Historic Preservation Commission Meeting

January 07, 2026

LOT 51 - BLUE CRAB PRIVATE
RESIDENCE

Cover letter addressing plan review comments for COFA-09-25-019927
Lot 51,4 Blue Crab Road – Tabby Roads

4 BLUE CRAB STREET - TABBY
ROADS, BLUFFTON, SC
29910

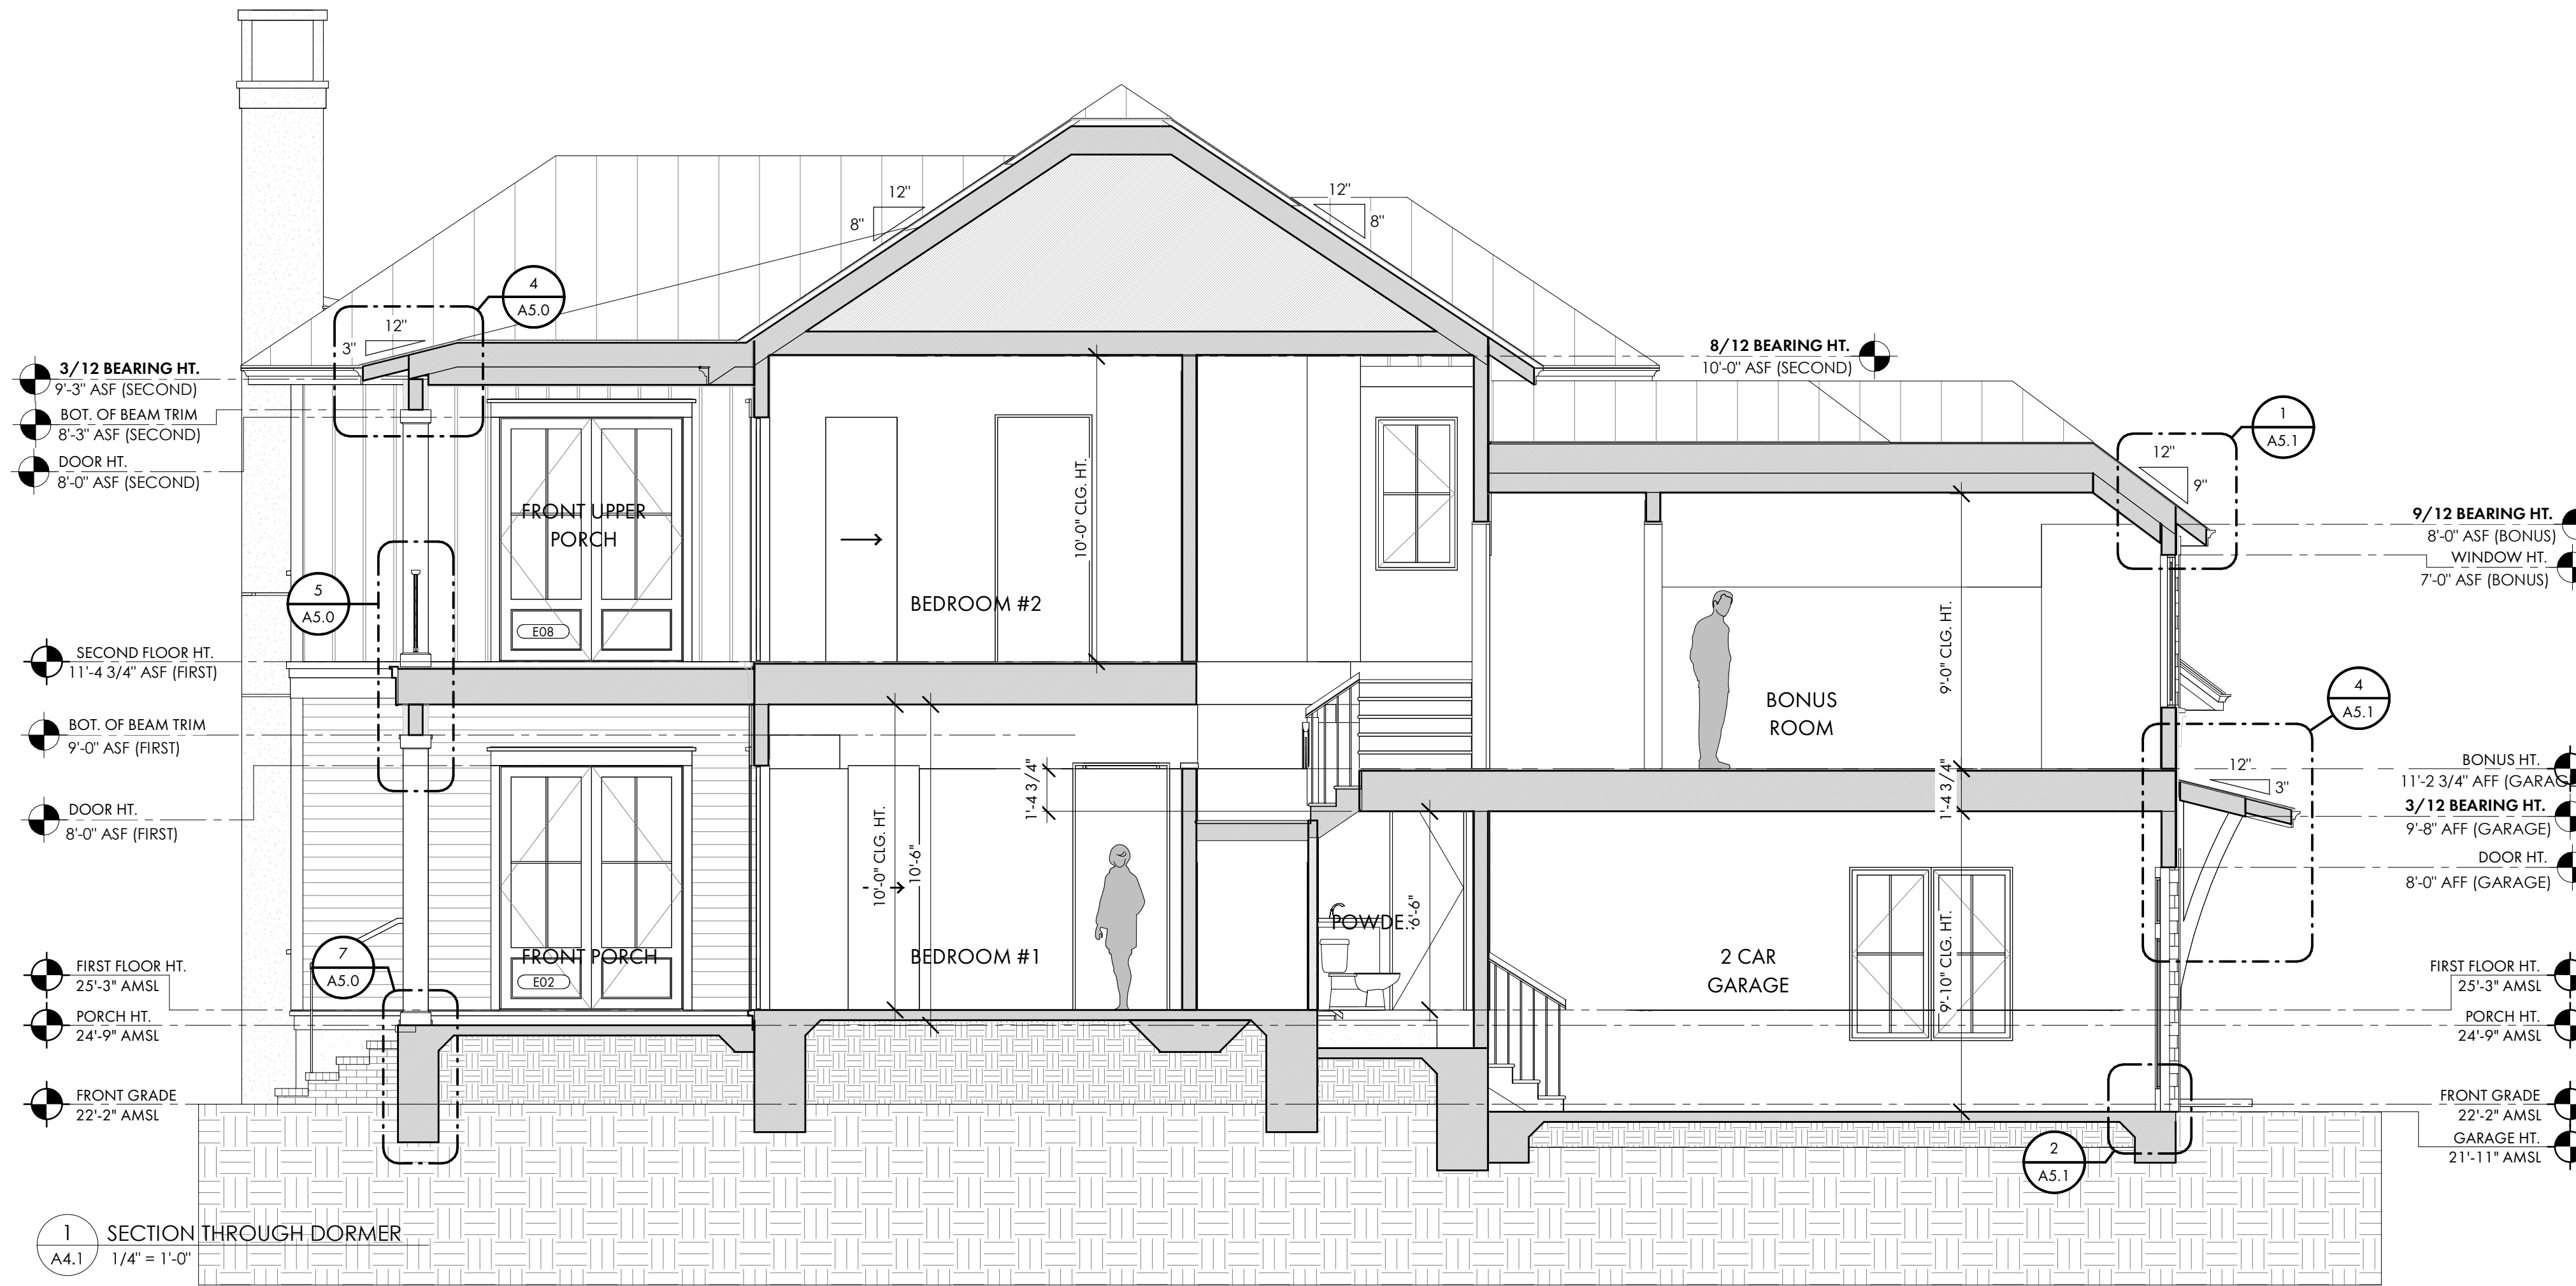
10. Rear Double Porch Detail: Show the interior elevations of the porch that are not visible.

- Please see accompanying building sections on sheet A4.0 and A4.1 showing interior areas of the porches
